City of Santa Cruz

**DOWNTOWN
~~RECOVERY~~ PLAN**

As Amended through _____ 2017

This document shows changes made to the July 21, 2016 version with strike-over and underlined text. Yellow highlights indicate modifications from the August 18, 2016 Planning Commission meeting.

HOUSING

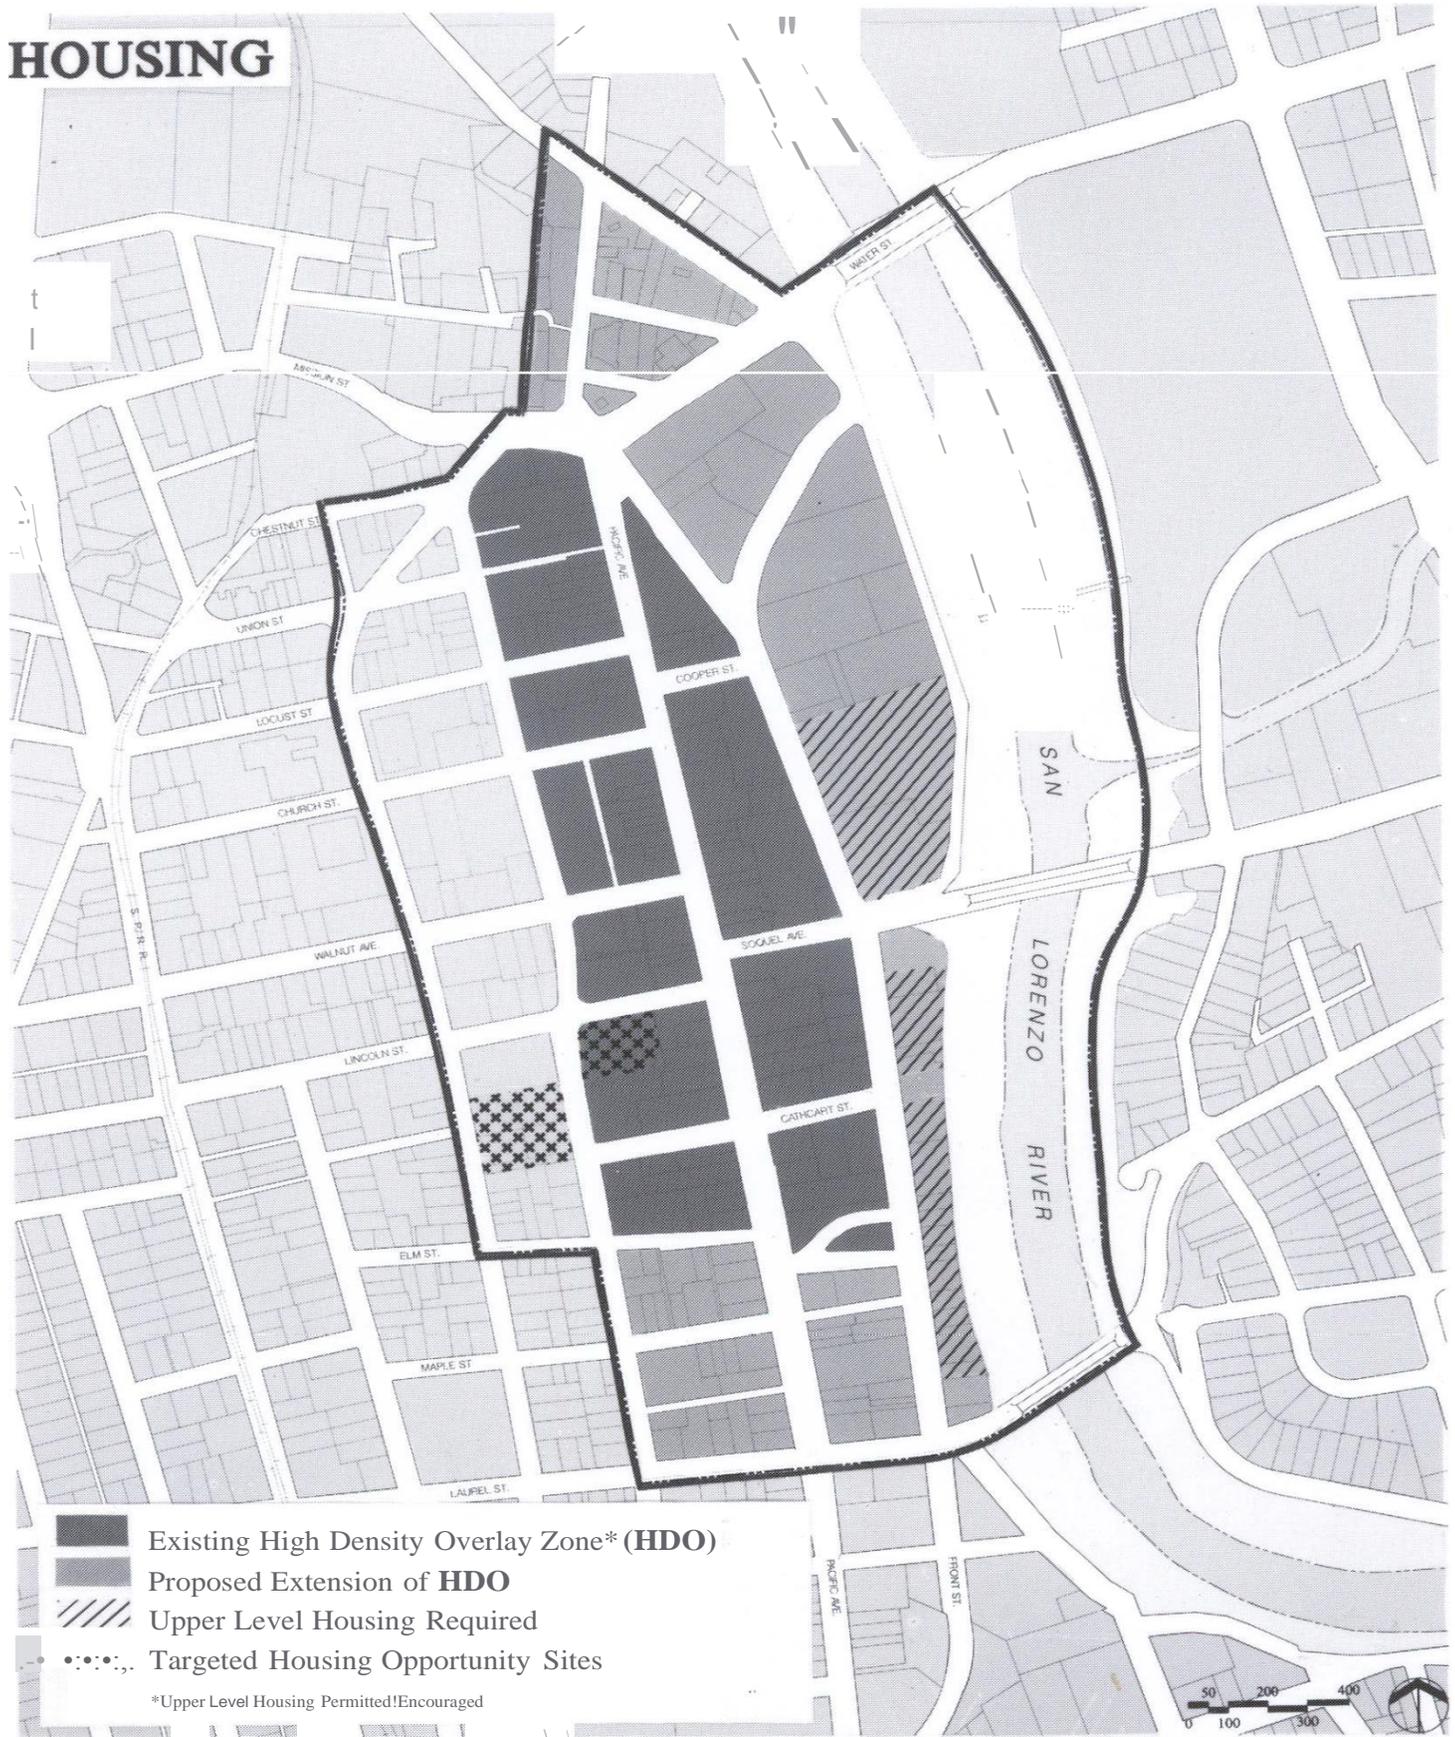
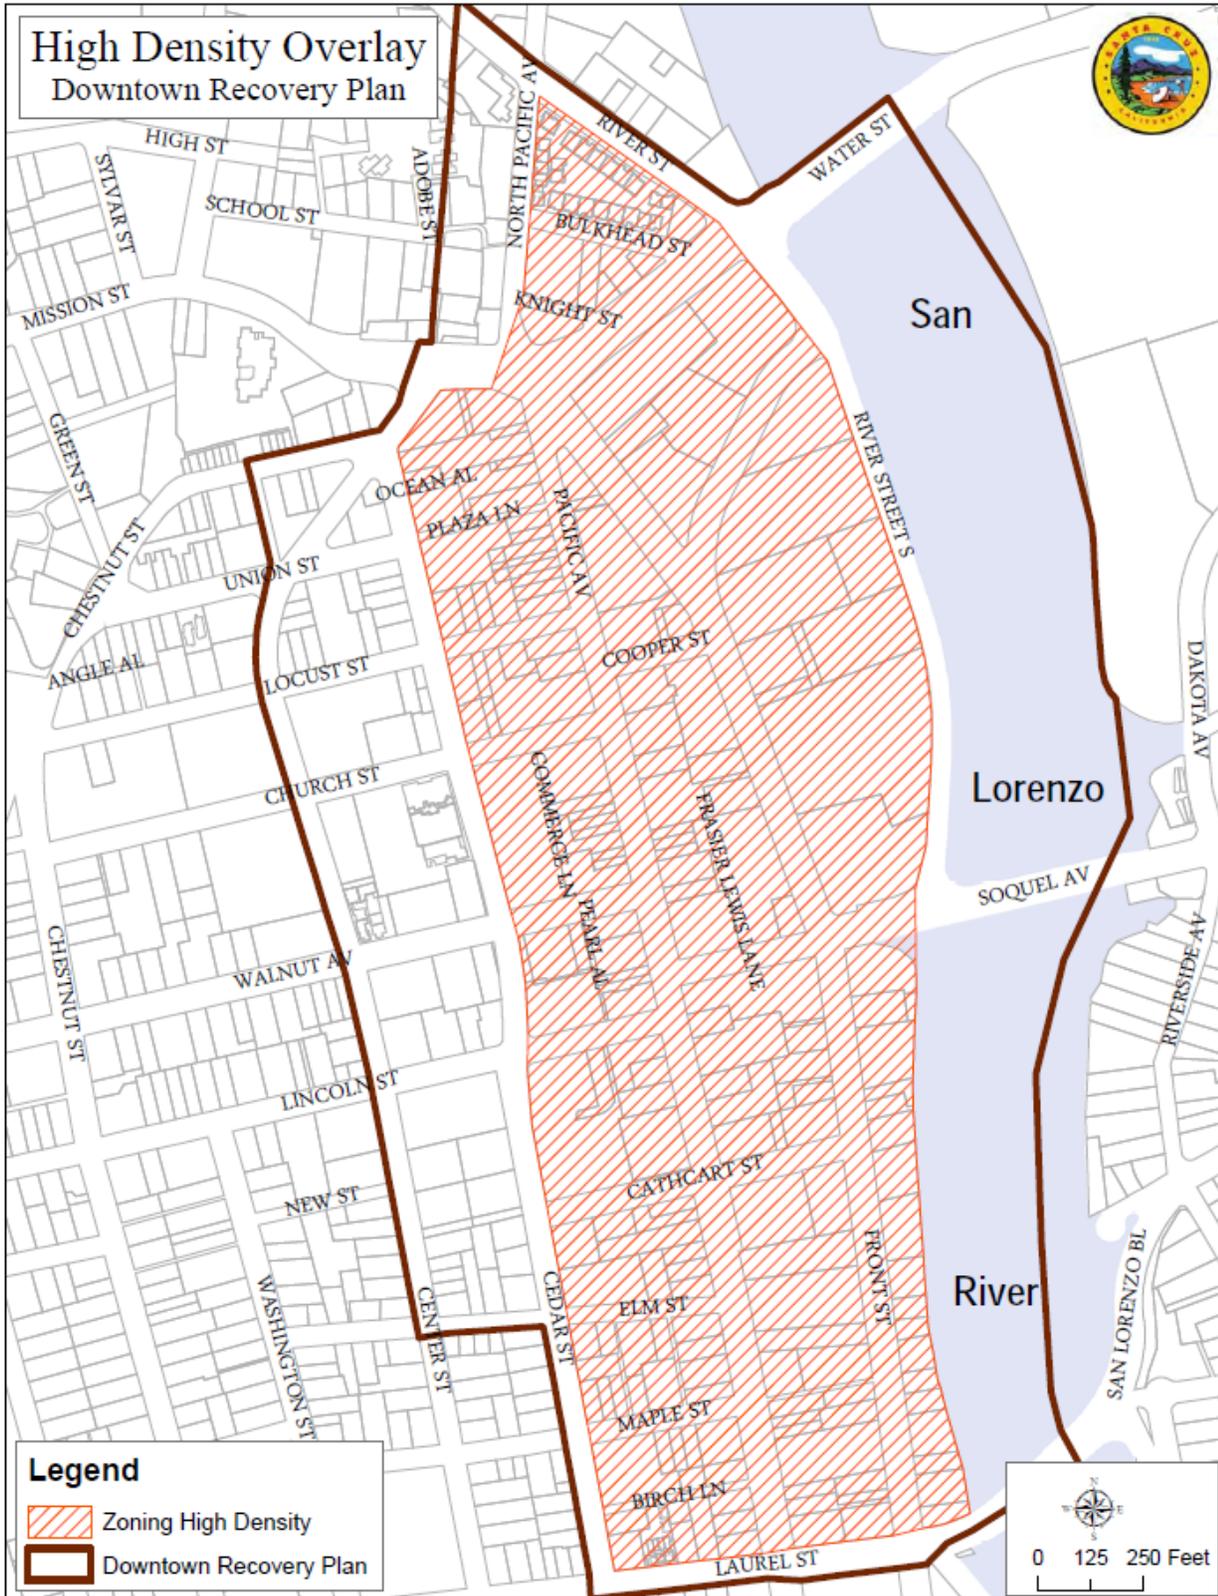
NOTE: The High Density overlay map will be eliminated as the General Plan 2030 land use designations have FAR ranges that supersede the HDO

Figure A-1: Downtown Plan Height

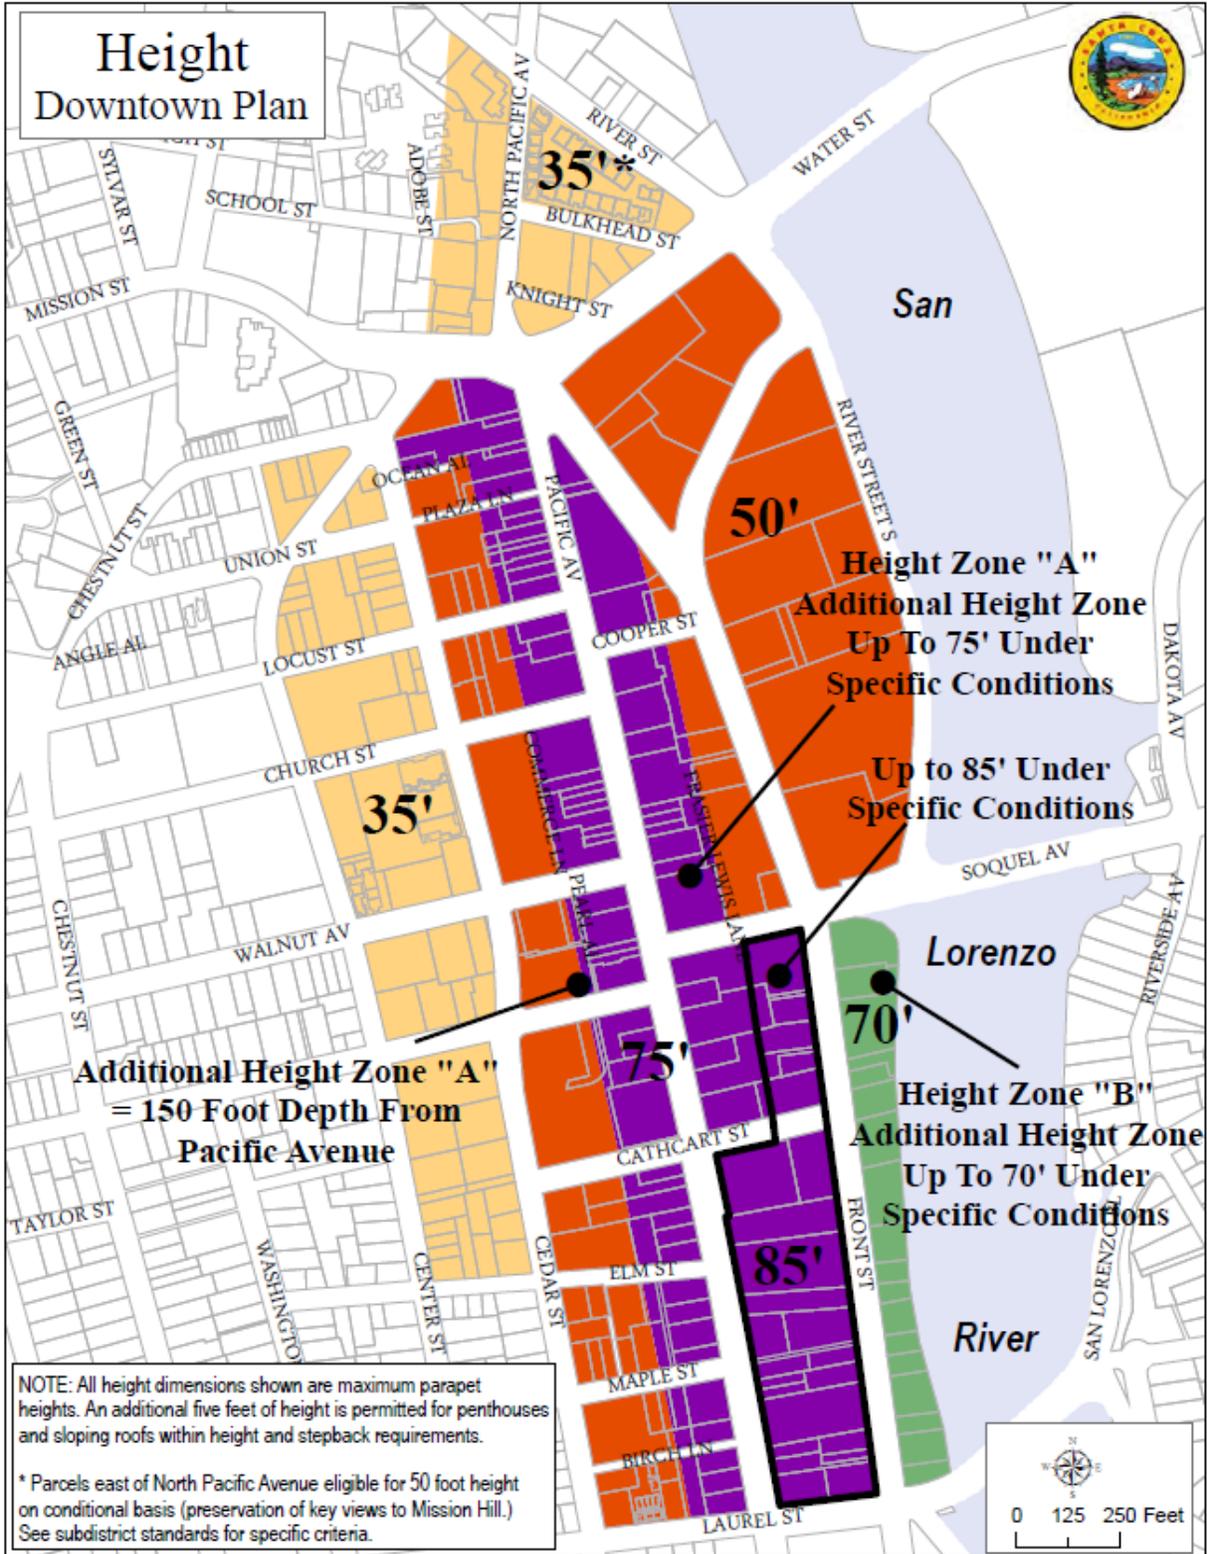
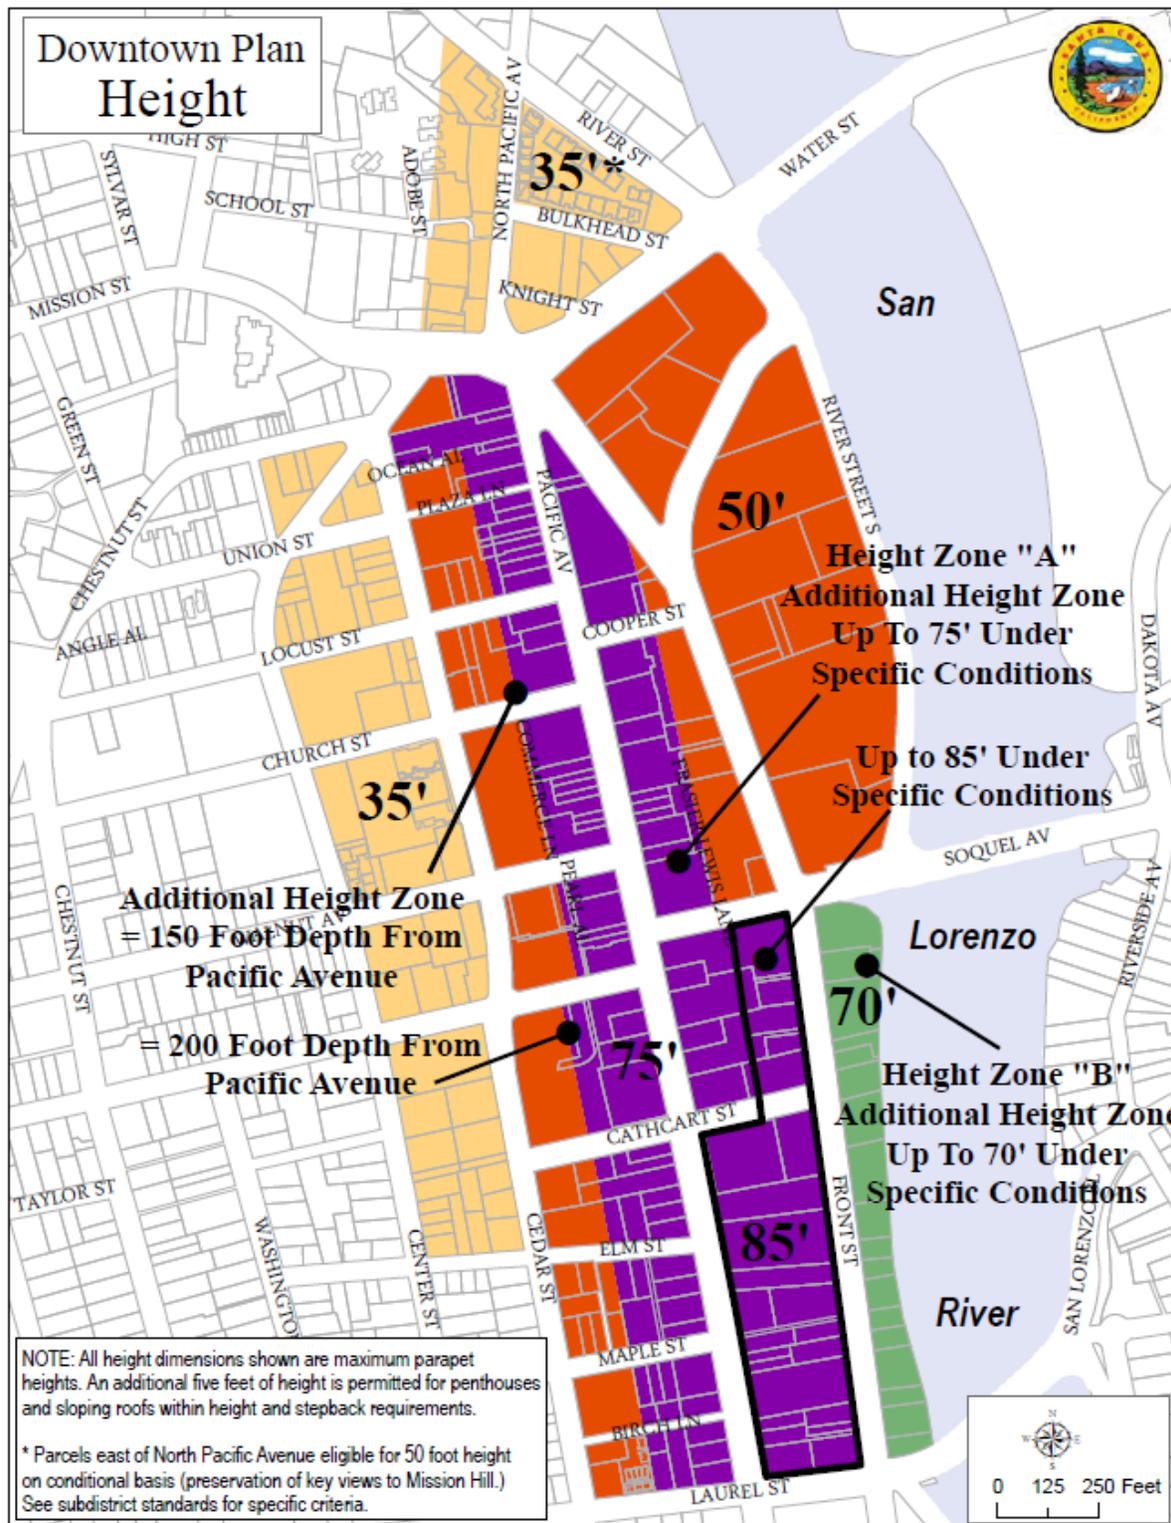
located on the east side of Cedar Street between Mission Street and Ocean Alley, and the west side of Front Street between Cathcart and Laurel Streets shall be considered within the “Additional Height Zone A”, within which ~~buildings meeting certain criteria may request~~ additional height above the 55 foot Base Height limit ~~may be requested for buildings meeting certain criteria-~~ (See Figure A-1: Downtown Plan Heights diagram). ~~It is t~~The intent of the Additional Height Zone A ~~is~~ to preserve the overall character ~~and scale~~ of the ~~historic-existing~~ development pattern, while allowing a discretionary intensification of use and increased height to maintain a compact urban core. **For eligible development projects that overlap the Base Height and Additional Height Zone boundary, all portions of the project exceeding the 55 foot base height shall be located within to the Additional Height Zone as shown in Figure A-1.**

Figure E-1: Proposed base and additional height and stepback requirements along the Front Street/Riverfront Corridor.

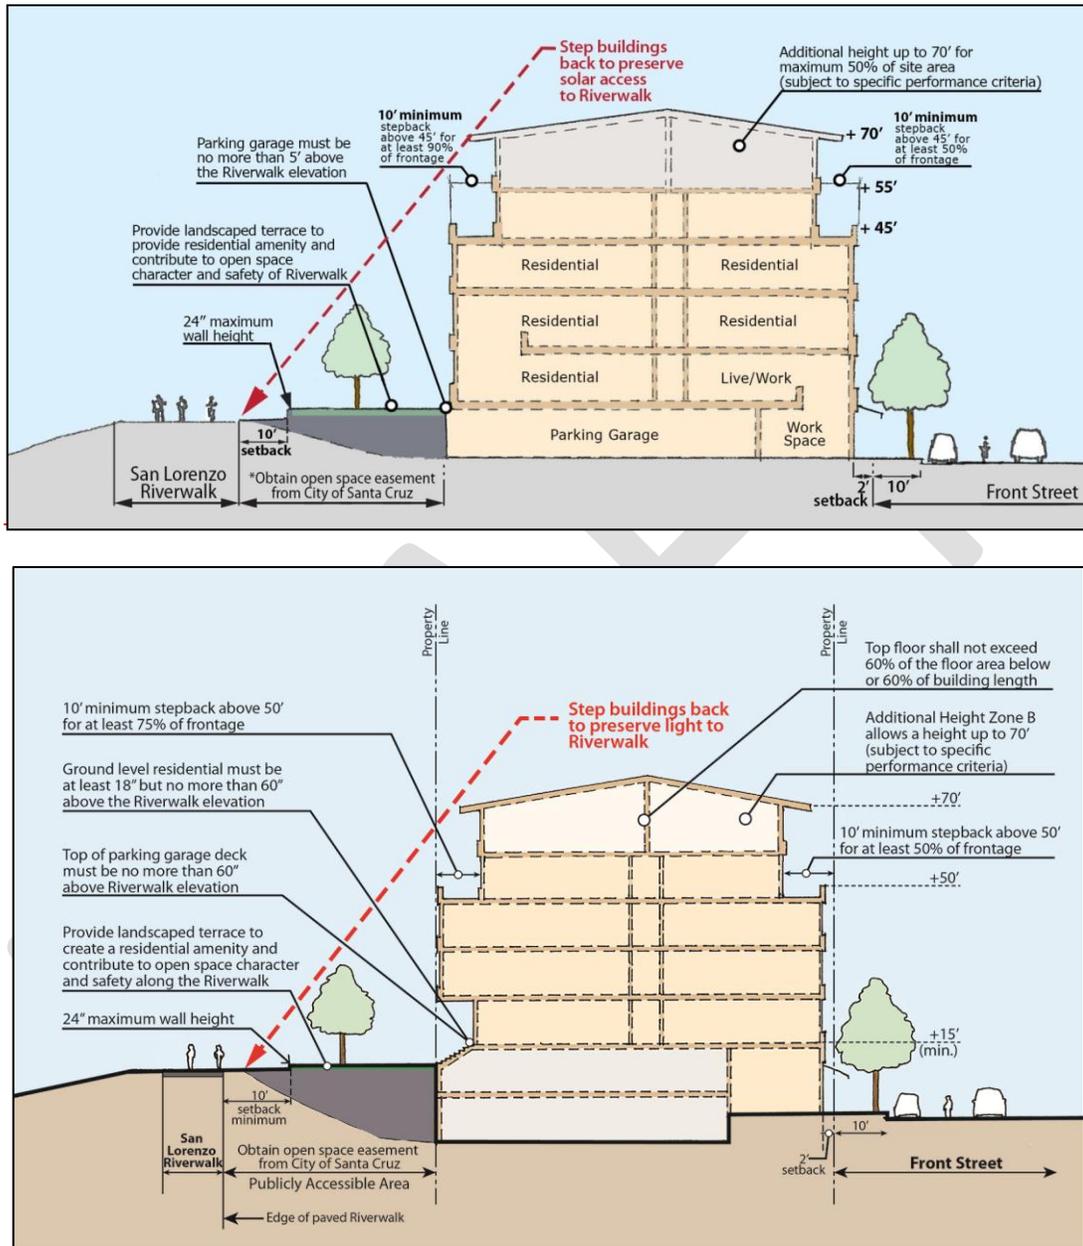
- a. Base Height and Floors. No new development shall exceed a base height of 55-50 feet (measured to the top of parapet or eaves on the highest floor). Within this base height, no more than 4-3 stories of commercial uses (including ground-level retail) shall be permitted; if upper-level residential or hotel uses are included, a maximum of 4-3 floors with a mix of such uses above the ground-level retail use will be permitted within the maximum base

~~b.d. Upper Level Stepback from River.~~ Along the west side of the Riverwalk, development shall step back 10 feet from the exterior wall face above the ~~45-50~~ foot height level as measured from Front Street sidewalk elevation. Allow up to ~~10~~25% of the Riverwalk building frontage to encroach into the required 10-foot stepback area to provide for massing variation. (See ~~above diagram~~ ~~Figure E-1~~).

Figure E-2: Proposed building massing and public access requirements along Front Street and the riverfront.

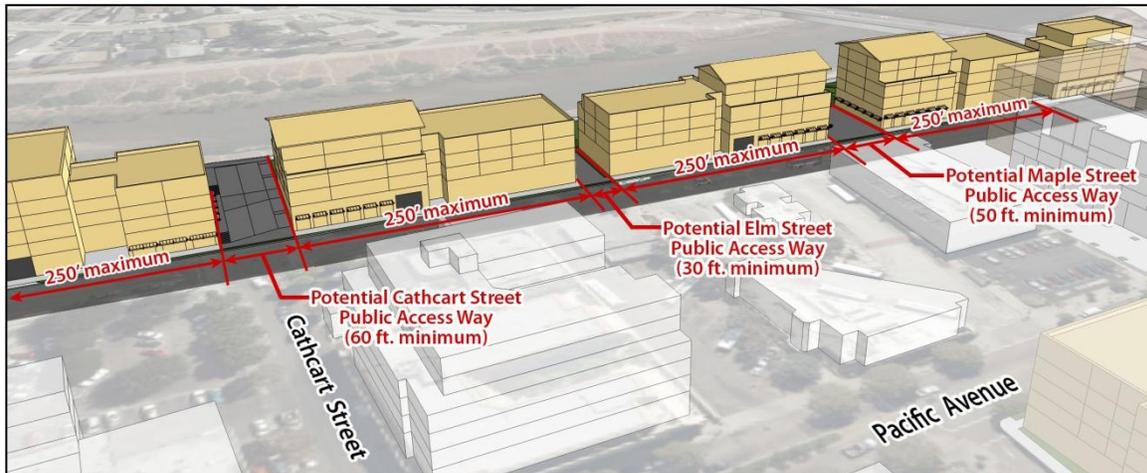
~~e. Building Length.~~ Between Soquel Avenue and Laurel Street, limit the length of individual buildings along Front Street to a maximum of 250 feet of lineal street frontage, subject to the performance criteria for improved public access to the ~~Riverwalk~~ ~~river~~ from Front Street ~~at the key connection points of Cathcart Street, near Elm Street and Maple Street.~~ (See ~~Figure E-2~~)

e. Encroachments. Development along the Riverwalk ~~promenade~~ shall not encroach beyond the property line of the parcel, except in cases where levee-facing “people- ~~oriented~~” commercial activities incorporate public access points to the Riverwalk. Top floor

cantilevered portions of the building are allowed to encroach over the property line a maximum of 5 feet in order to provide architectural interest to the façade. Such cantilevered encroachment over the property line shall not exceed ~~40~~25 percent of the total building frontage along the riverfront.
